CP-200901549  
Log # TXNB-09061

**SUBJECT:** COMANCHE PEAK NUCLEAR POWER PLANT, UNITS 3 AND 4  
DOCKET NUMBERS 52-034 AND 52-035  
RESPONSES TO REQUESTS FOR ADDITIONAL INFORMATION  
NO. 2757, 2819, 2836, 2837, AND 3592

- Attachments
1. Response to Request for Additional Information No. 2757 (CP RAI #67)
  2. Response to Request for Additional Information No. 2819 (CP RAI #66)
  3. Response to Request for Additional Information No. 2836 (CP RAI #68)
  4. Response to Request for Additional Information No. 2837 (CP RAI #69)
  5. Response to Request for Additional Information No. 3592 (CP RAI #71)

**Figure 13.1-205 CPNPP Units 3 and 4 Plant Staff Hiring and Training Plan**

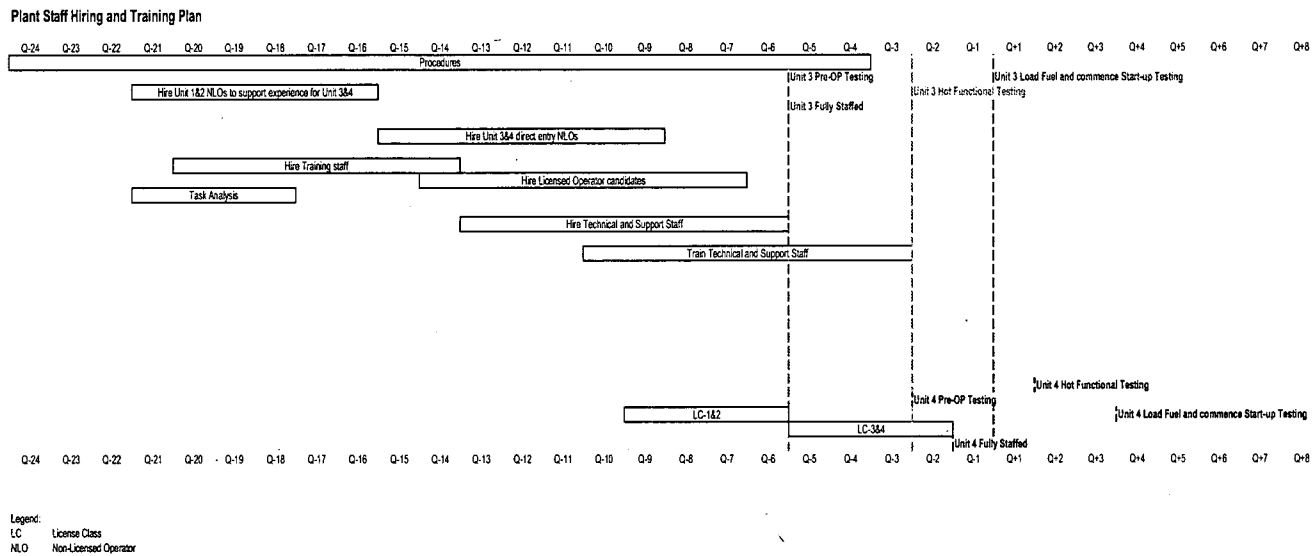
Standard Review Plan Section 13.1.1, "Management and Technical Support Organization," section I.1.B.ii states that the applicant should provide a description of the plan for the development and implementation of the applicant's staff recruiting and training programs. FSAR section 13.1 does not appear to include a description of the plan to develop the staff recruiting and training programs.

The plant staff training program is provided in Section 13.2. These plans will be substantially accomplished before preoperational testing begins as shown in new FSAR Figure 13.1-205, "CPNPP Units 3 and 4 Plant Staff Hiring and Training Schedule." Reactor operator (RO) and senior reactor

FSAR Figure 13.1-205 is based on information of NEI 06-13A, "Template for an Industry Training Program Description." This template has been developed by the New Plant Training Task Force, which is the subject of an on-going discussion under the operator readiness task force meetings. Figure 13.1-205 shows the relative positions of hiring and training milestones (i.e., first license class, etc.) for the various types of personnel (i.e., licensed operators, non-licensed operators, technical and support personnel). The staffing plan for CPNPP Units 3 and 4 nuclear personnel, based on ANSI/ANS3.1-1993 functional positions, is provided in FSAR Table 13.1-201.

See attached marked-up FSAR Draft Revision 1 pages 13.1-12, 13.2-1, 13.2-2, and new Figure 13.1-205.
